City of Tacoma

Questions and Answers #2

Water Ditch Trail IIIA RFB Specification No. PW23-0130F

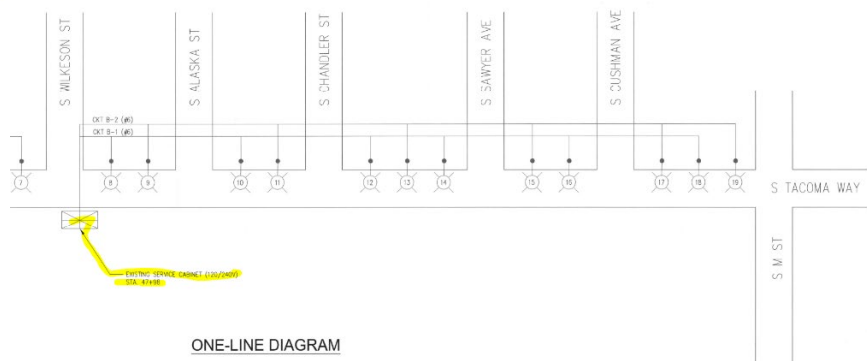
Question 1: Can you confirm whether the service cabinet noted in construction note 21 plan sheet SG1-1.02 is existing or new? It's noted as furnish and install new service cabinet but when looking at the referenced illumination plans on sheet IL-1.08 It seems to be existing.

FURNISH AND INSTALL NEW SERVICE PER ILLUMINATION PLANS.

Answer 1: The plans are asking for a new service not a new service cabinet. The intent is to reuse the cabinet and install new circuits per sheet IL-1.08.
